Revision:V.1.2

File: DONGLE02.SchDoc

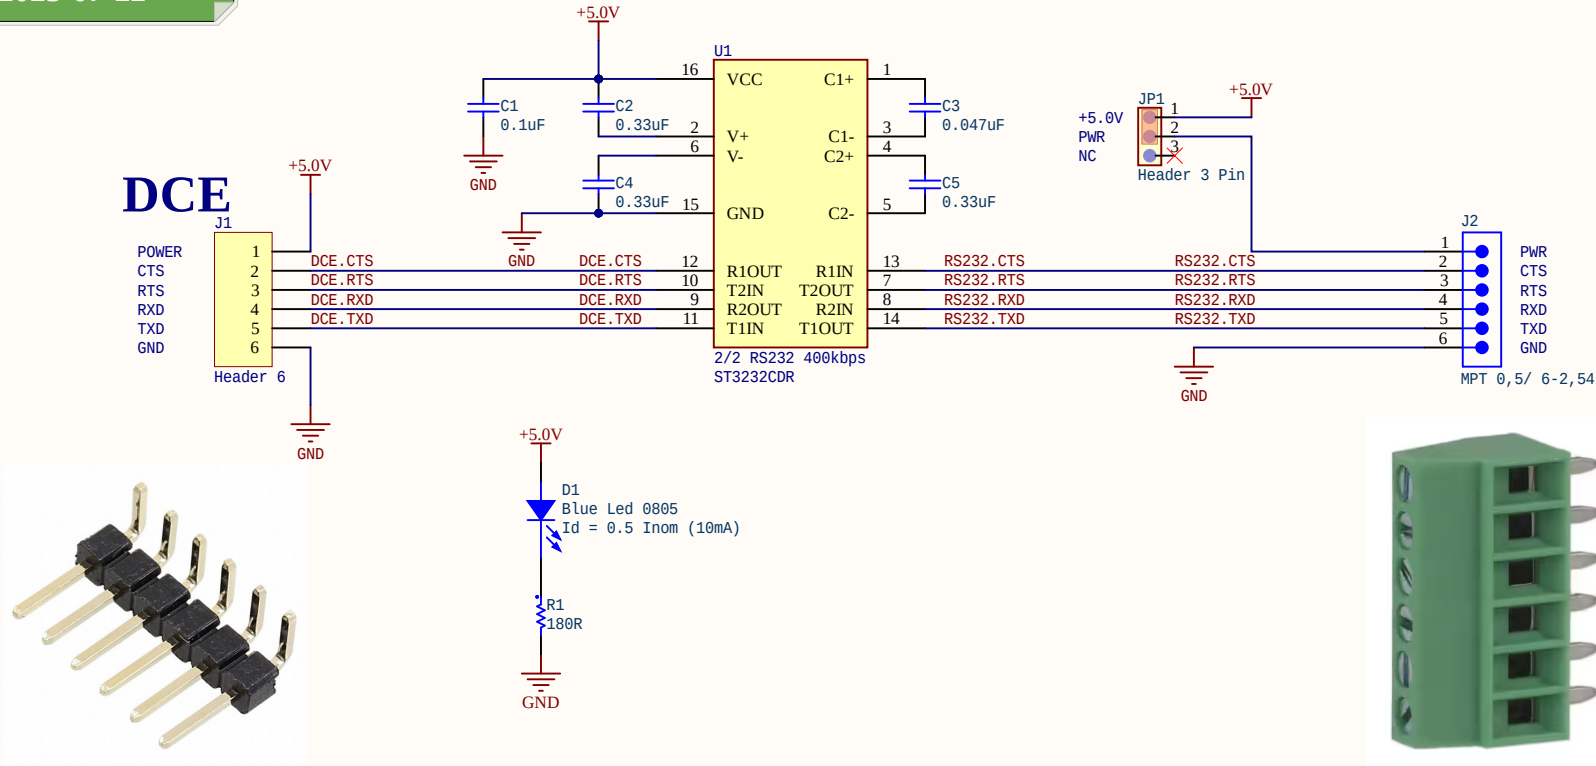
Bug detected: RX,TX,RTS and CTS need to be swaped. New version of PCB needed.

Bug Fixed at 2025-07-22
